34<sup>th</sup> Street Pump Station Improvements Project  
SAWS Job No. 13-6004  
Solicitation No. CO-00072-RA

**ADDENDUM No. 2**

October 14, 2016

**3 DETAIL**  
SCALE: NTS

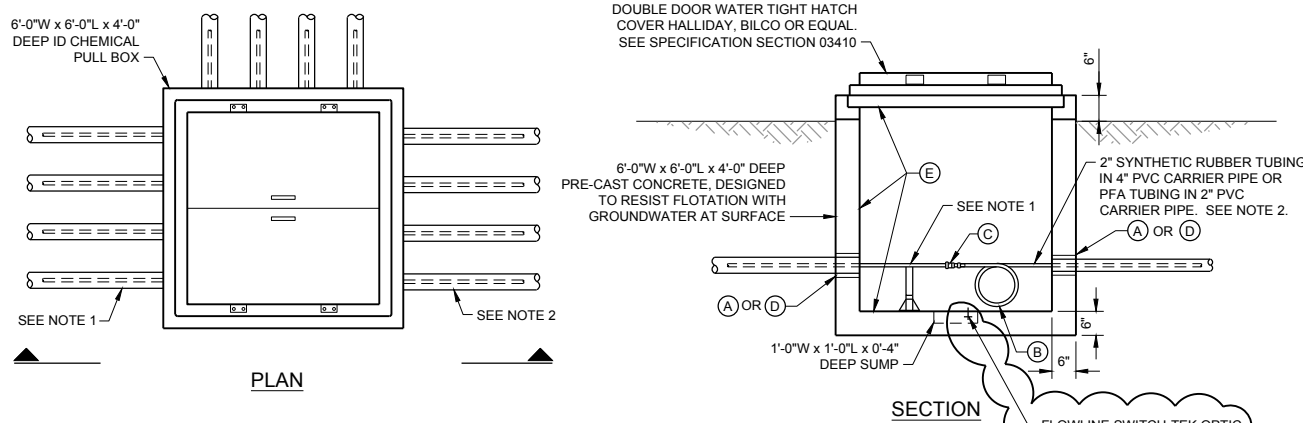
Drawing D-502, Detail 3: There is no PVC tubing. It is either PFA tubing or rubber hose.

Drawing D-502. Detail 3: There is no pull box near the Chem Bldg for the HF acid. CCB-1 is 35' away.

Revised to show leak detector in the chemical containment box (previously included but not shown).

***Response: PVC tubing will be changed to tubing or hose. See revised drawing.***

***Response: Transition to PFA tubing for Hydrofluosilicic acid will take place in the tank containment area.***

**D-308**

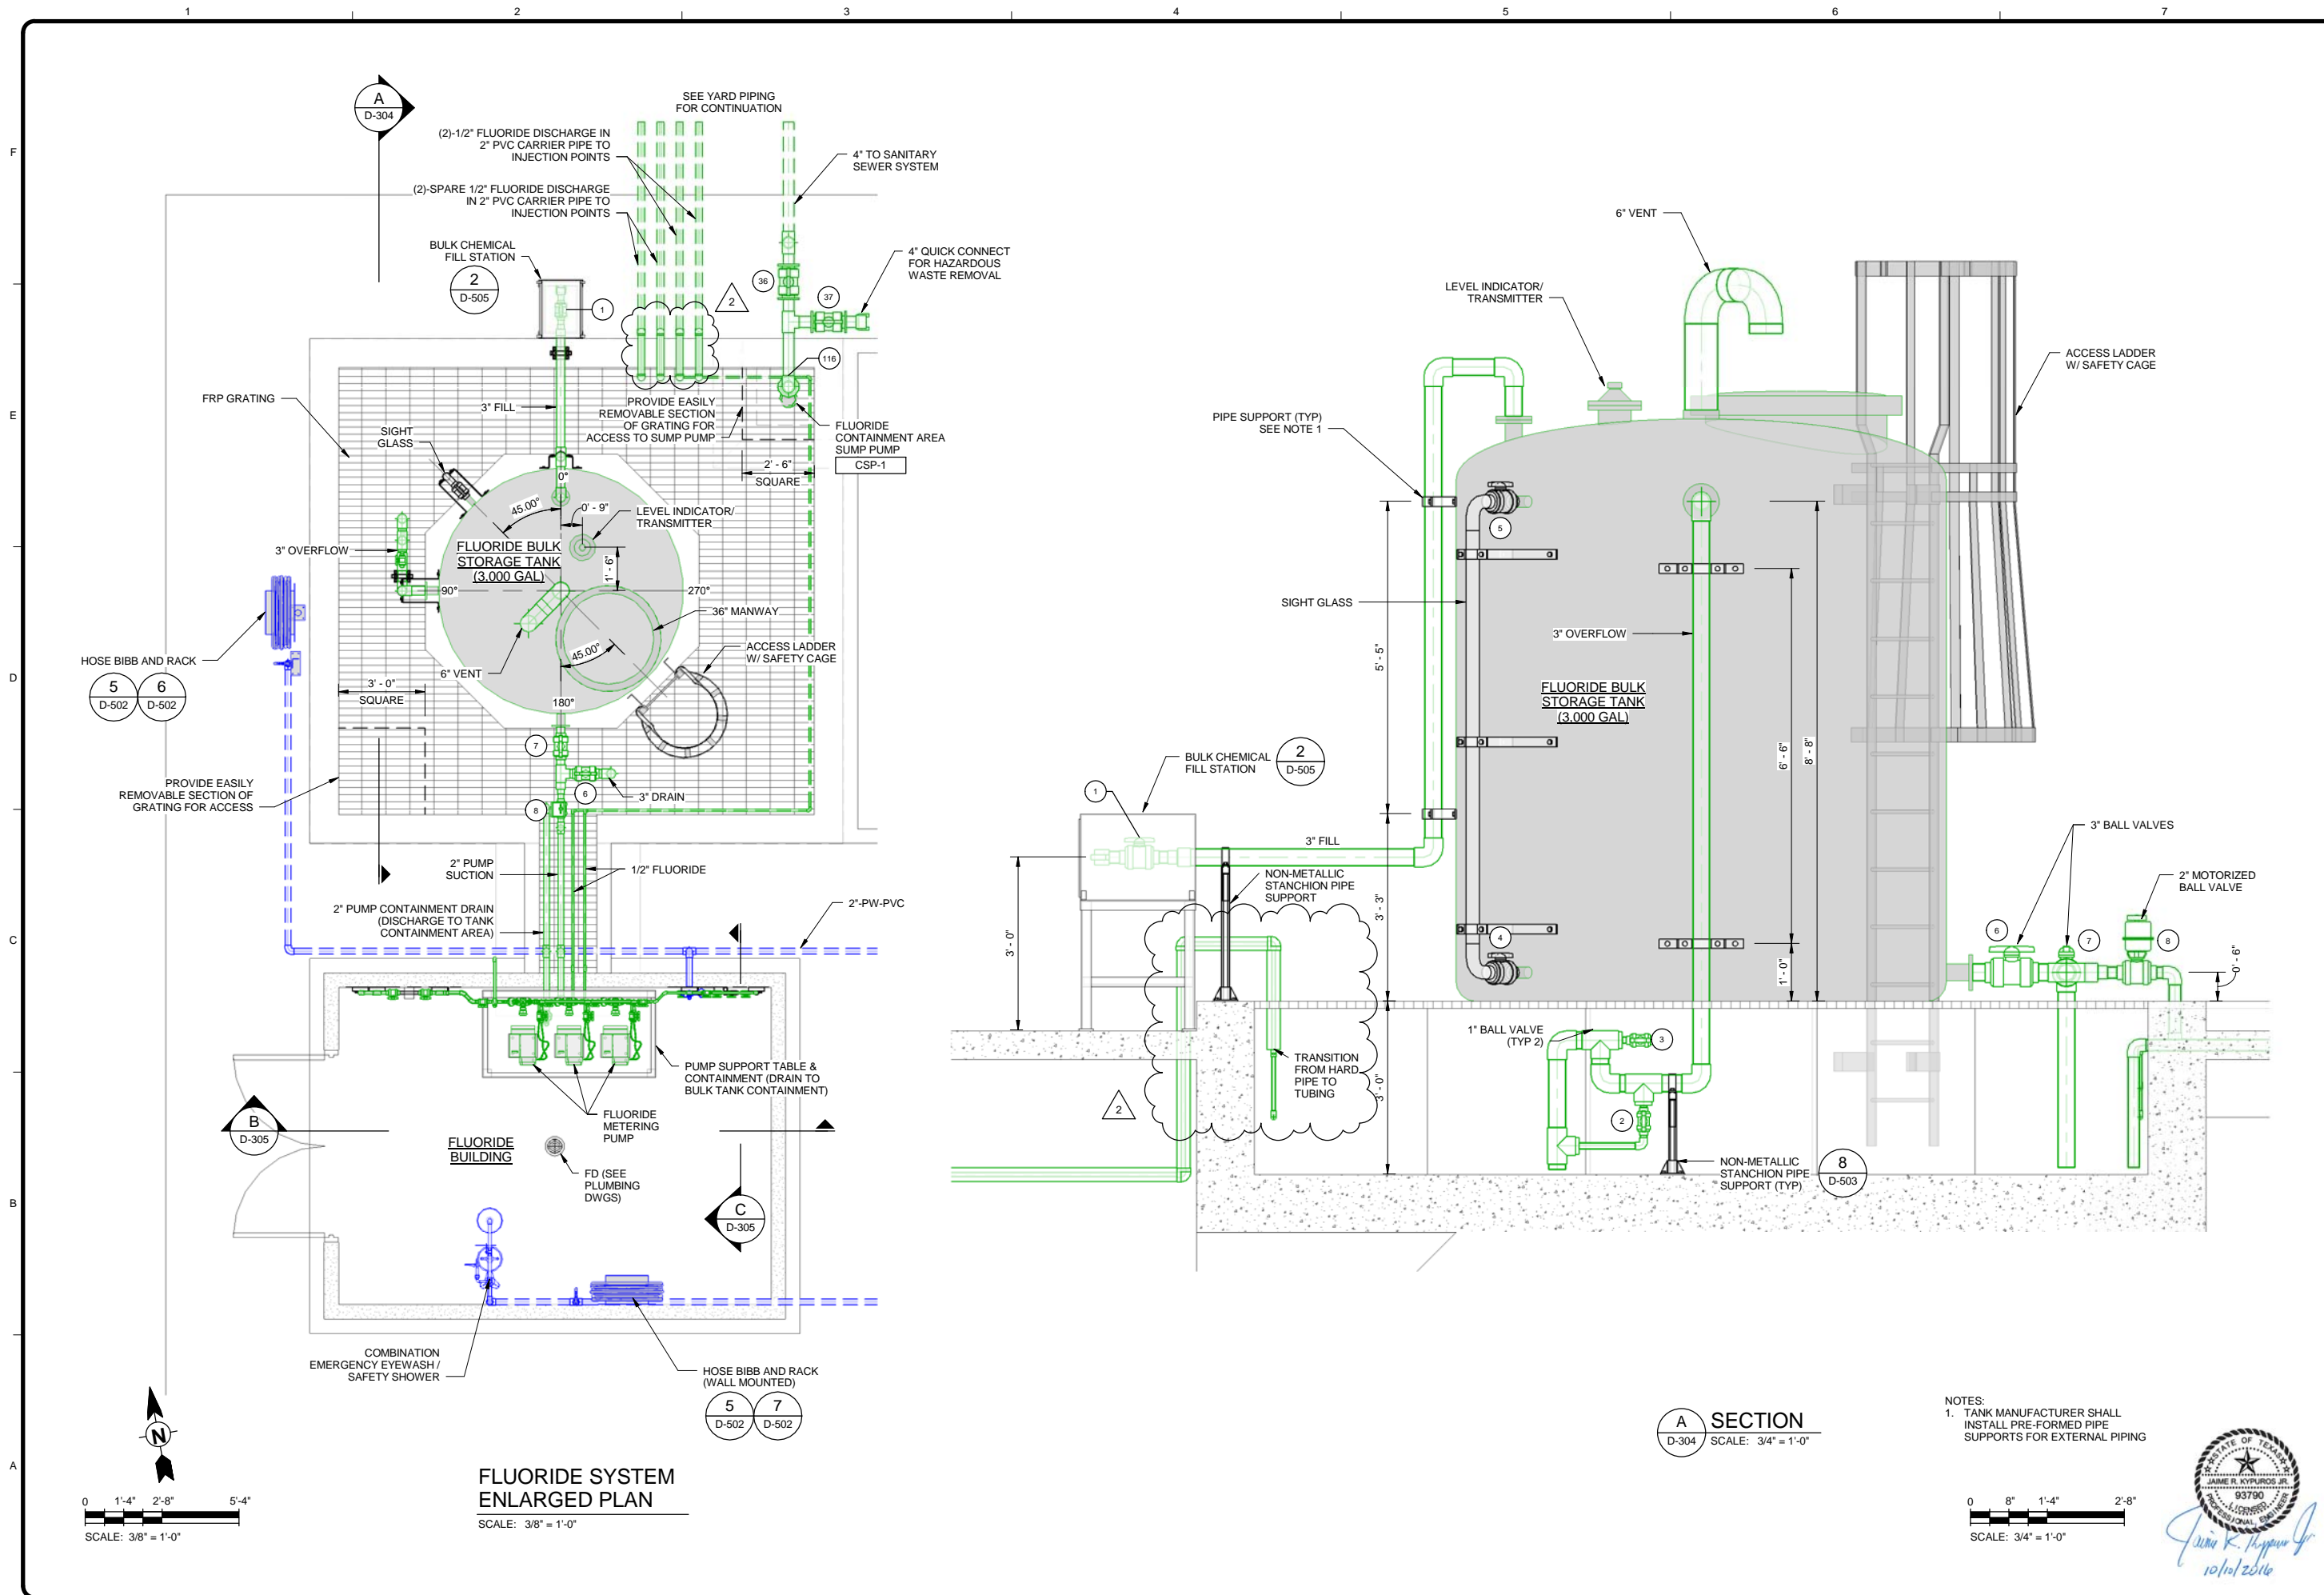
Sodium hypochlorite piping revised to extend back over tank containment area wall. (Drawing still being updated.)

**D-304**

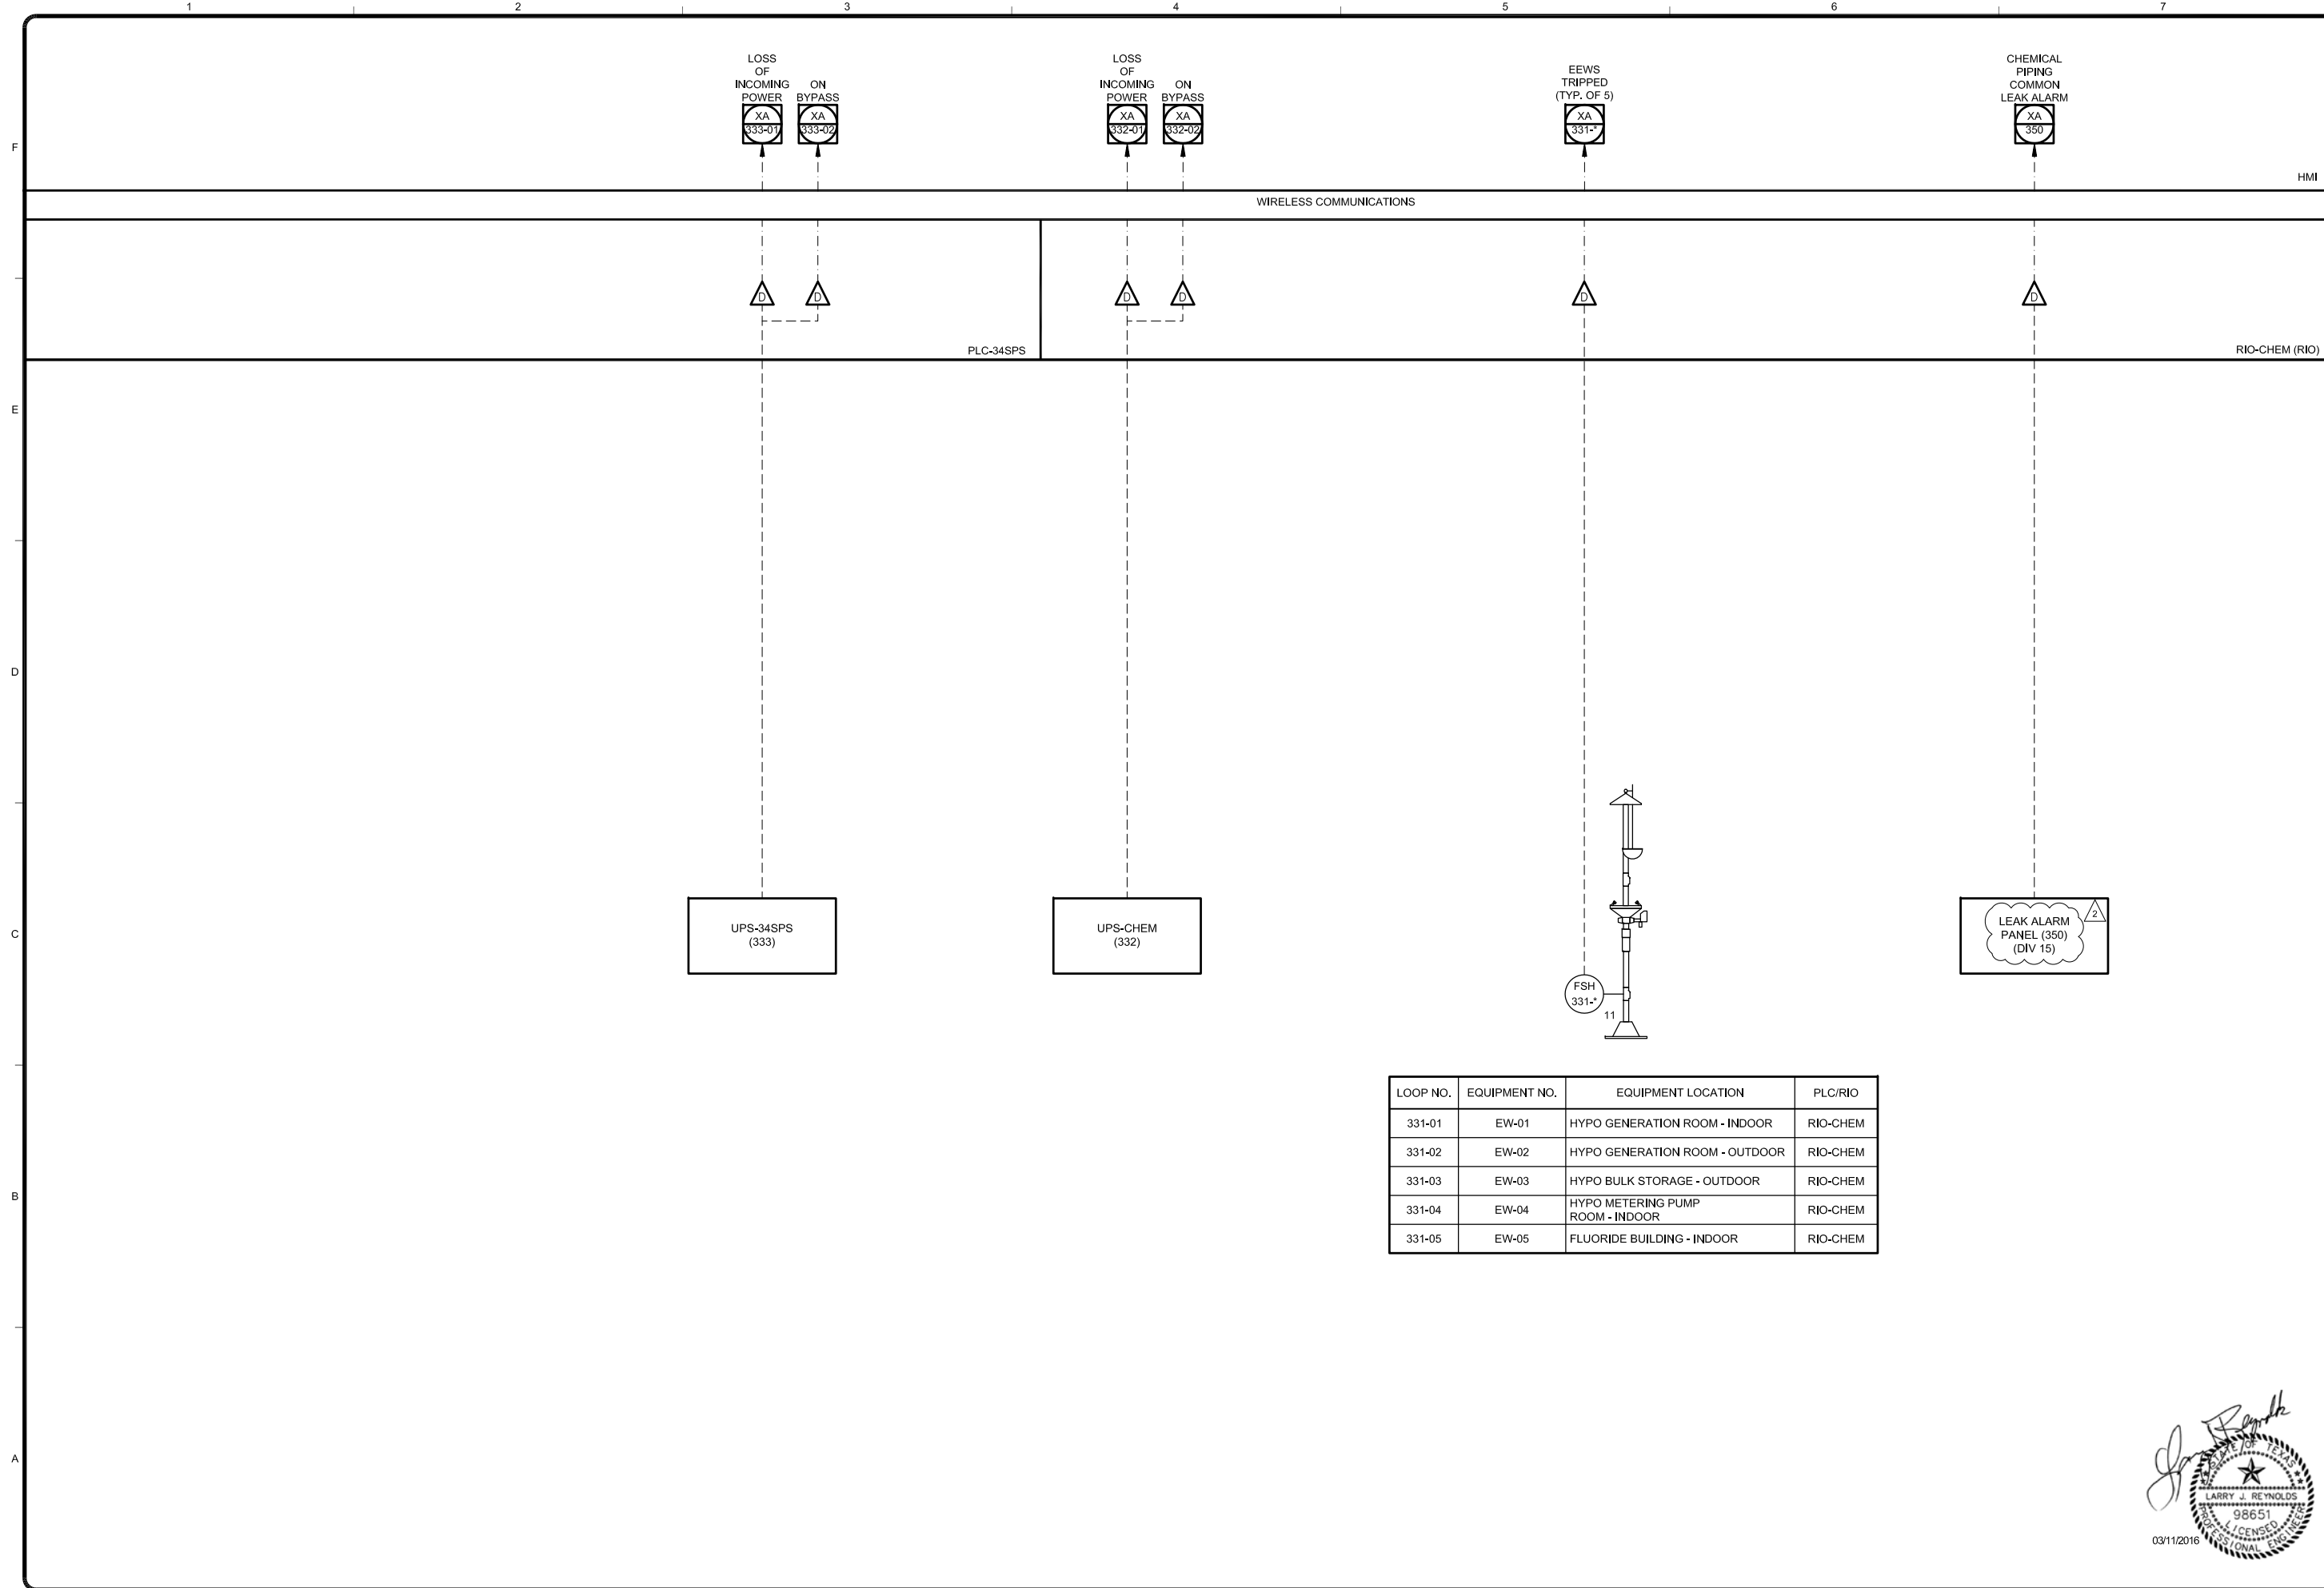
Fluoride piping revised to transition from hard piping to tubing inside tank containment area. Secondary containment pipe revised to extend over wall back into containment area.

**I-305**

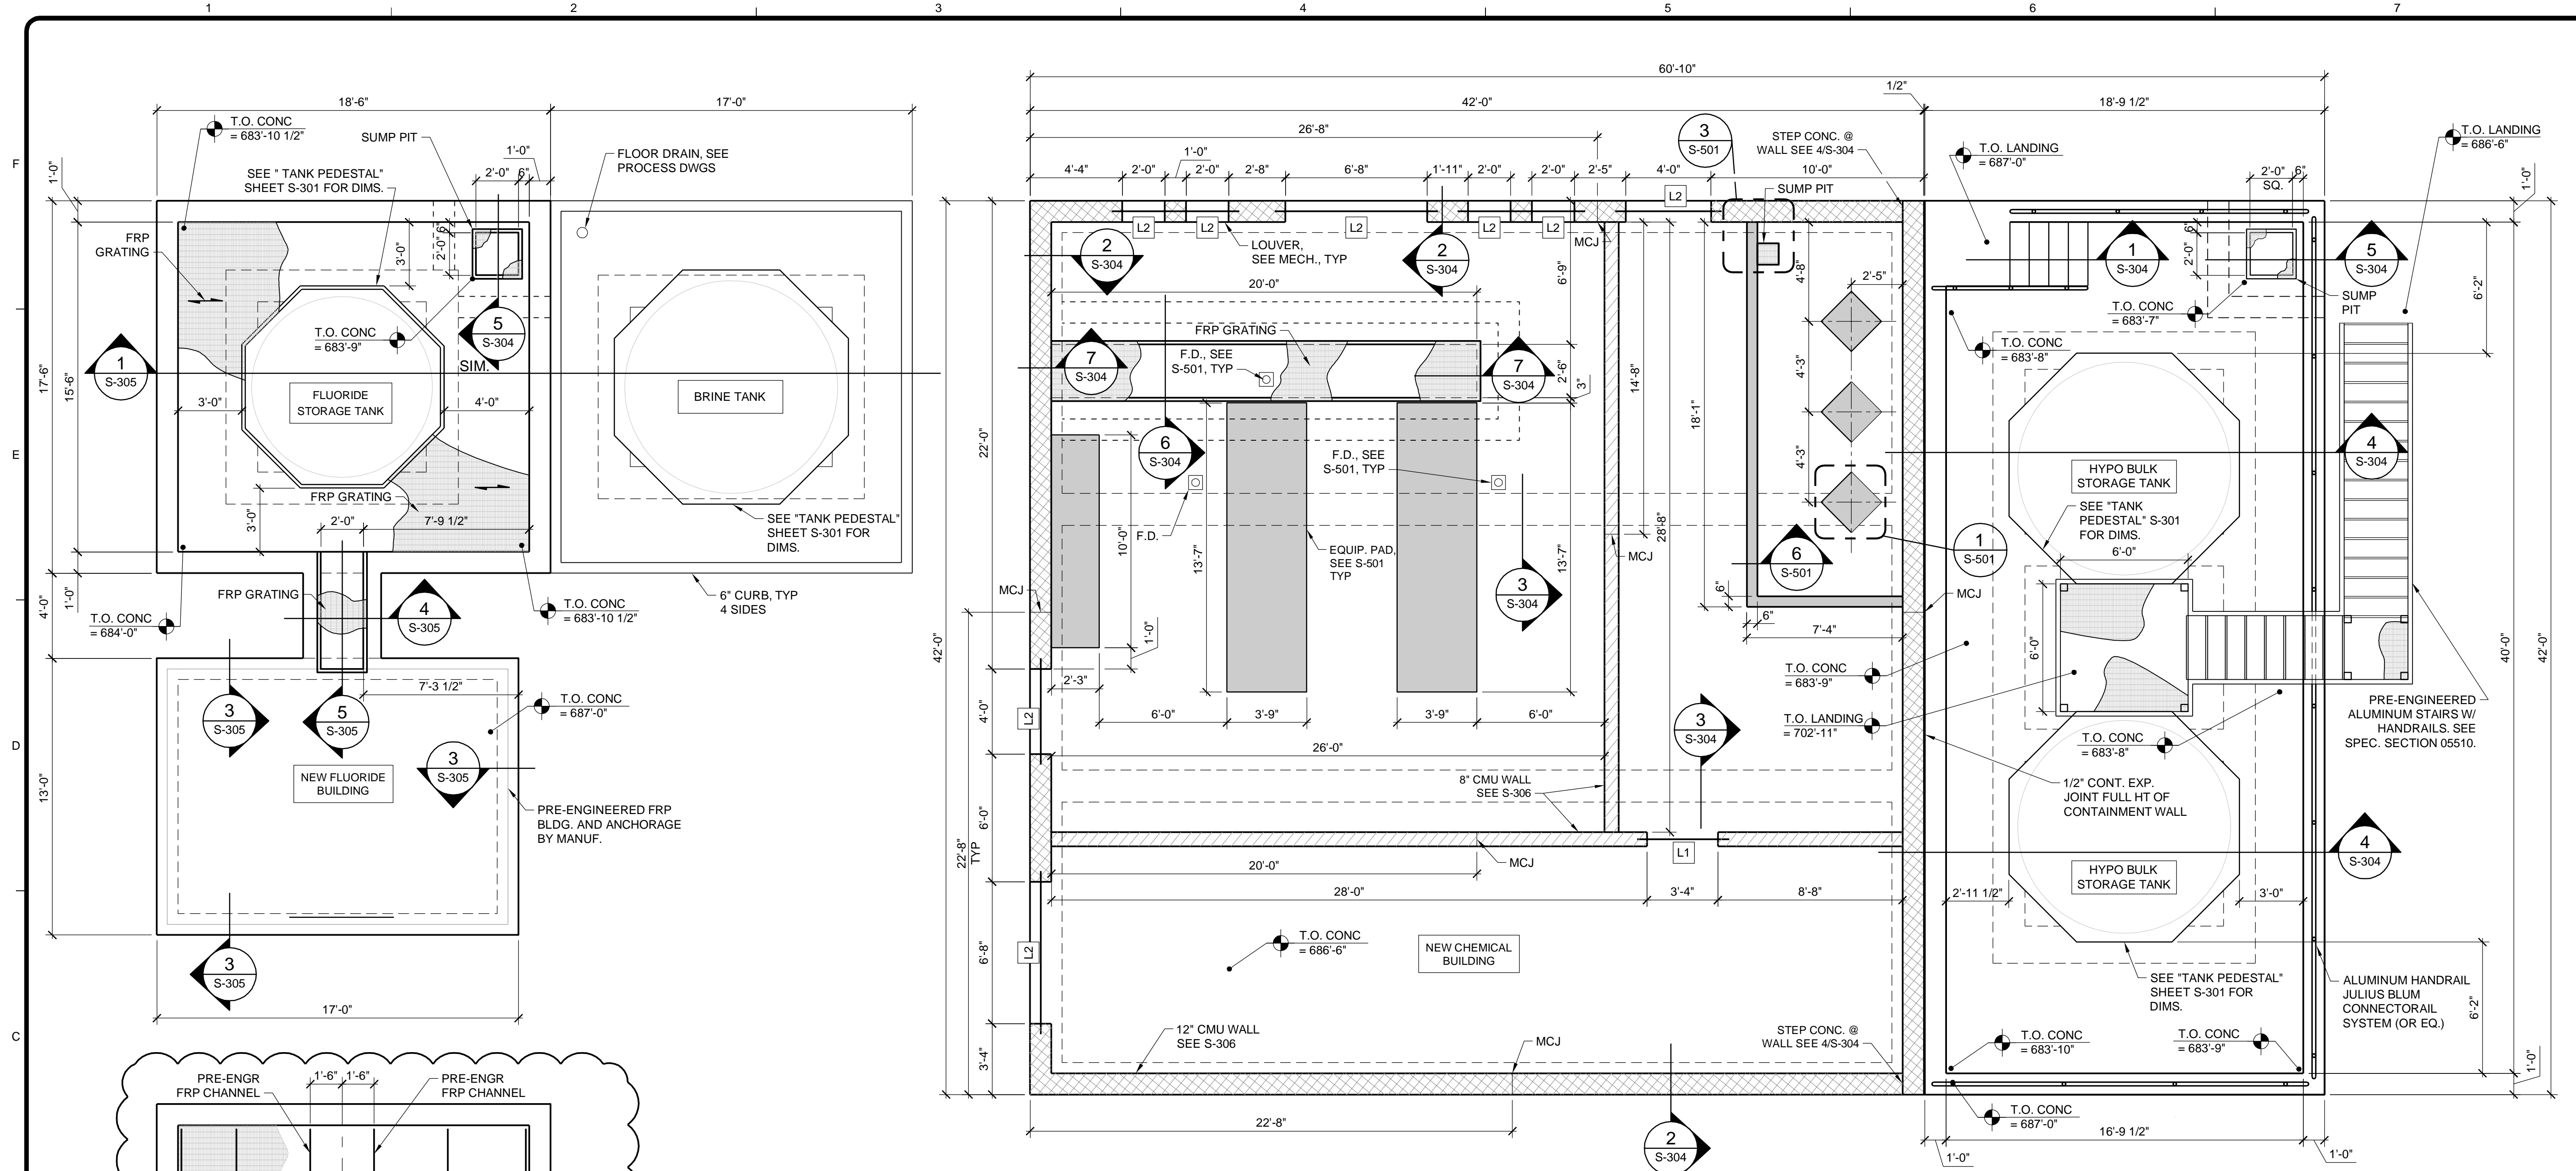
Changed to reference Division 15 instead of Division 11.
